Date: Middelfart, DENMARK, December 6<sup>th</sup>, 2023  
To: Hobie Class Members  
From: IHCA Rules Committee  
Subject: **Hobie 18 class rule change proposals**

John Forbes, Australia, has submitted a package of Hobie Cat 18 class rule change proposals. The outset is the “Hobie Cat 18 Reimagined”-project John has been working on for years and as someone is acquainted with already.

Photo 3.1

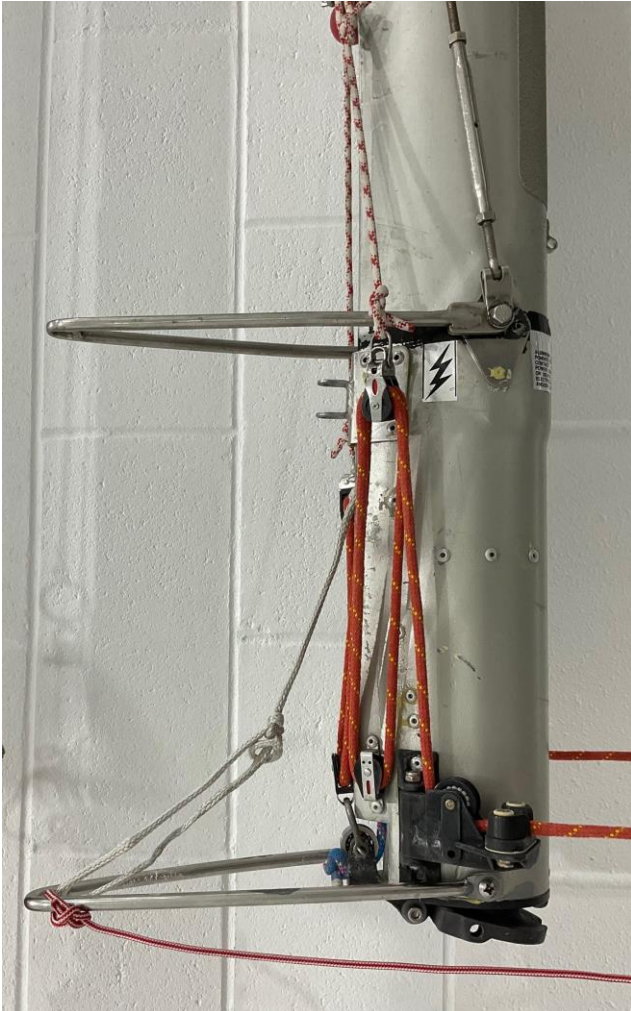
~~Additional~~ Mast rotation devices and related control equipment may be installed to the owner's and skipper's specification, provided it does not structurally weaken the mast or the boat or interfere with HOBIE CAT CO. components.

To allow the mast rotation arm to be moved from above the boom to the below the boom to prevent the jib sheet from snagging on the rotation arm during tacks and gybes. Noting also that teams are already

currently legally using a second rotation arm below the boom specifically for the downwind over-rotation control. Allowing this same arm to be used for the upwind mast rotation control is a logical update.

Photo 4.1

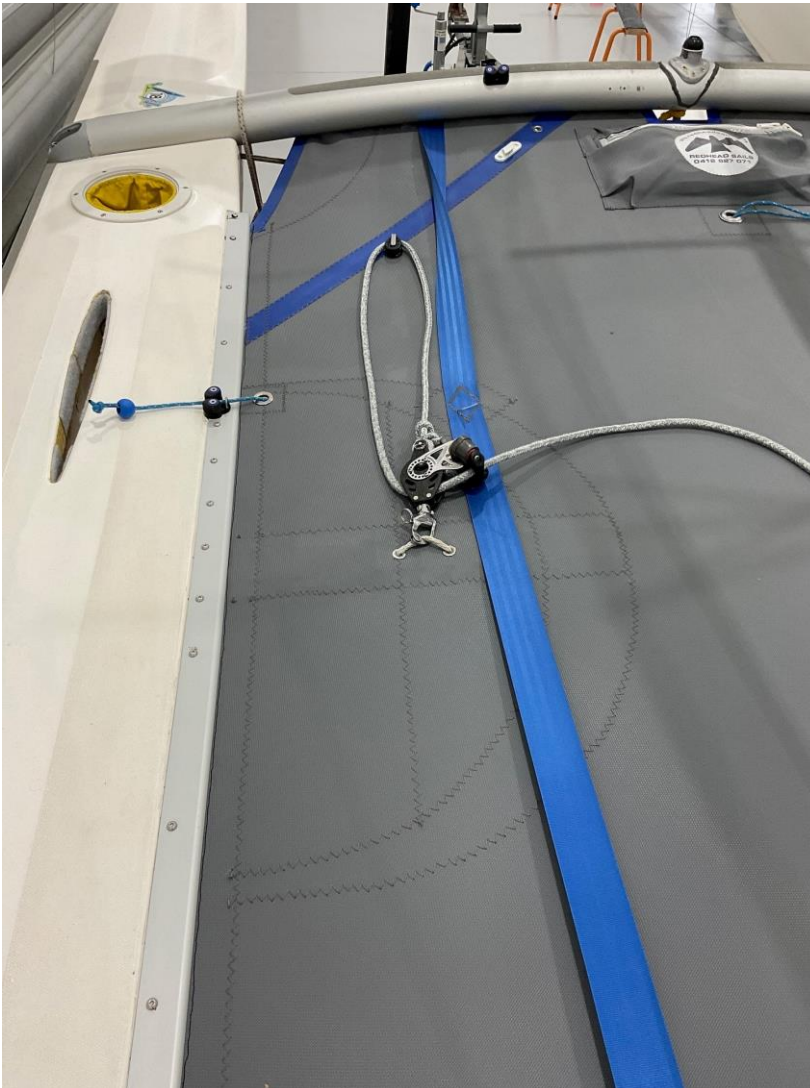
~~Additional~~ Jib cleats may be installed to the owner's and skipper's specifications provided their mounting does not structurally weaken the boat or interfere with other HOBIE CAT CO. components.

To allow the jib cleat block to be mounted on the trampoline.

Photo 6.5

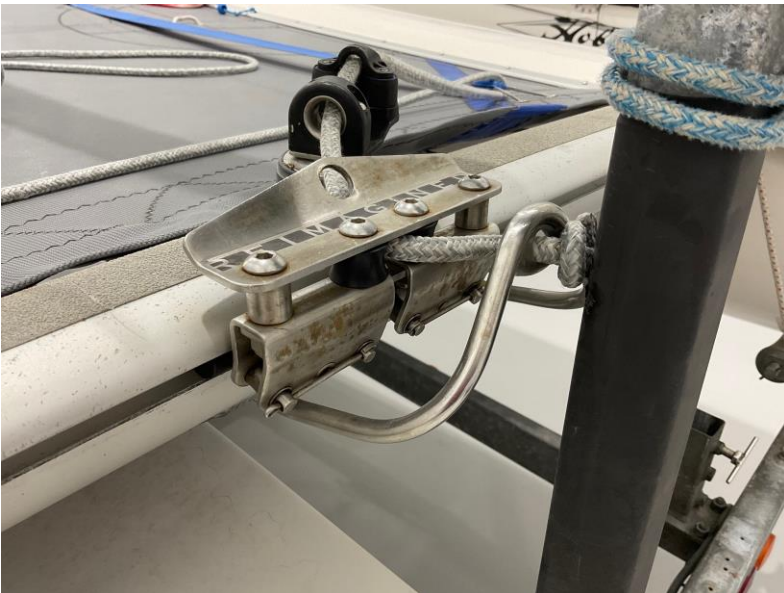
*Double traveller cars may be used. They shall be linked, and the sheeting angle and traveller line sheaves shall perform the same function as the original single traveller car.*

To allow double traveller cars. Double traveller cars have already been ruled as being class legal, but it is not currently defined in the class rules.

*Photo 6.3-6.5: There are a couple of versions of this currently being used by teams around the world. John is working on a version that utilises the maximum amount of existing parts as per photo 6.3 & 6.4 simply joined by a flat bar inside both cars. Photo 5 shows a double traveller car joined by a bar specially tailored for the purpose.*
